STAFF REPORT: OCTOBER 11, 2023 REGULAR MEETING

APPLICATION NUMBER: HDC2023-00051

ADDRESS: 4300 W. VERNOR

SCOPE: INSTALL WINDOWS AT SIDE WALL

1993 Historic Designation Advisory Board photo, arrow added to indicate missing arch.

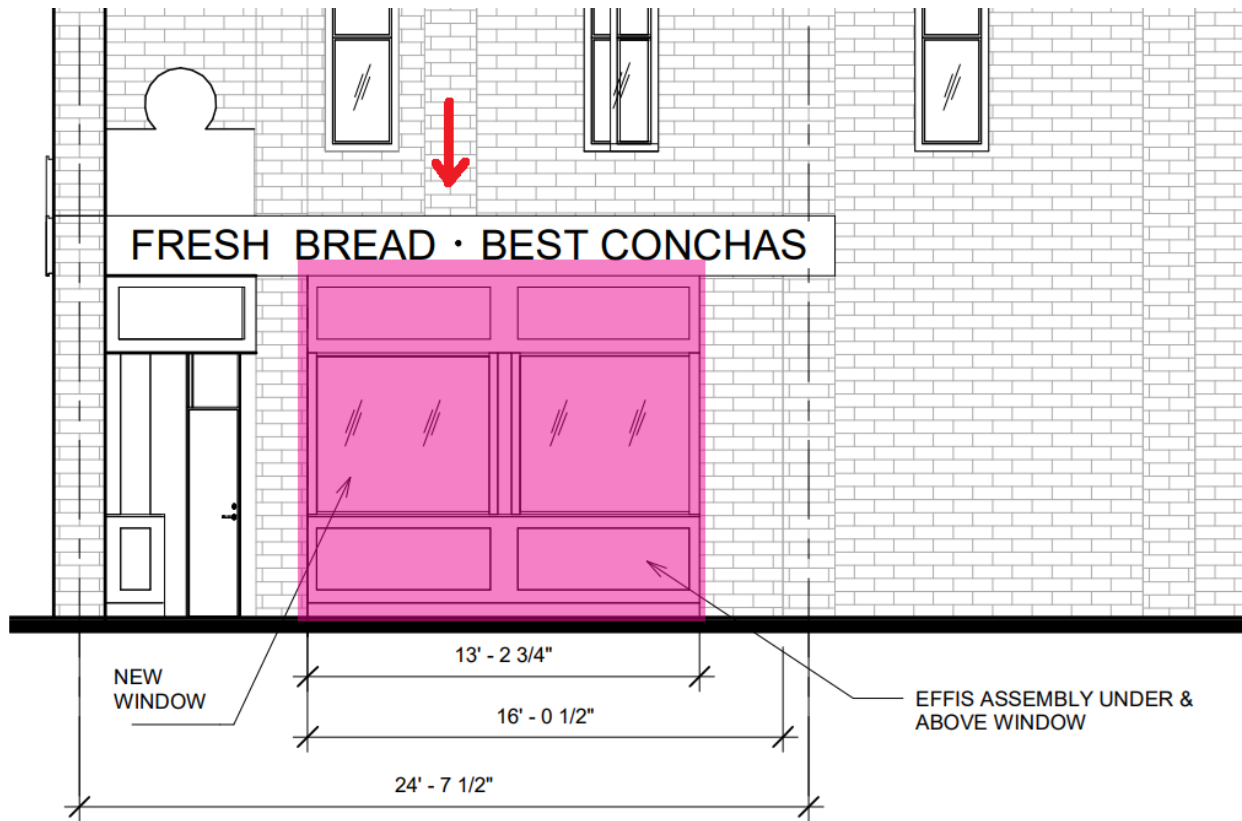
The ground-level storefronts have been altered since the 1993 description. Most prominently, a recessed, diagonal entrance bay has been created at the southwest corner, allowing access from Clarkdale Street in addition to West Vernor Highway. A vinyl awning and an expanse of T-111 siding have been removed. In their place, the present wood-panel and glass storefront has been added. Two business signs have been removed. Finally, a decorative arch, set within the central, south-facing doorway (noted in the HDAB description above) has been removed. Staff has no record of this work being approved by the Historic District Commission. The work meets the Secretary of the Interior's Standards for Rehabilitation, in the opinion of staff, except for the removal of the arch, which is not appropriate.

East elevation with proposed work highlighted in colored box. Image from application documents. Arrow added by staff to indicate pilaster location, discussed below.

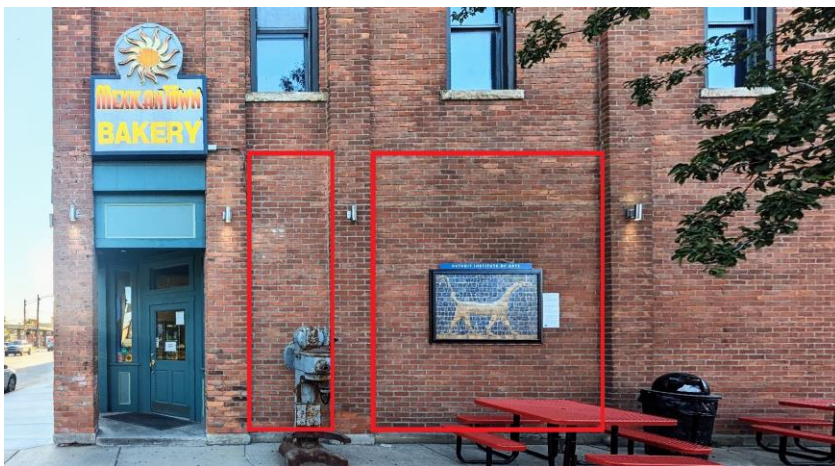
- The proposed location of storefront window openings, severing one of the pilasters at the first story, is not compatible with the vertical emphasis of the building, as described above, contrary to Standard #9.
- The proposed use of EIFS would introduce a new material that is not historically found in the Hubbard Farms Historic District, contrary to Standard #9.
- Specifications for the proposed sign are not provided.

- The proposed openings will be adjusted to avoid severing the brick pilasters on the east elevation.
- Wood, rather than EIFS, will be used for the unglazed portions of the storefront.
- The sign will conform to the *Sign and Awning Guidelines* or be approved by staff subject to the Secretary of the Interior's Standards for Rehabilitation.
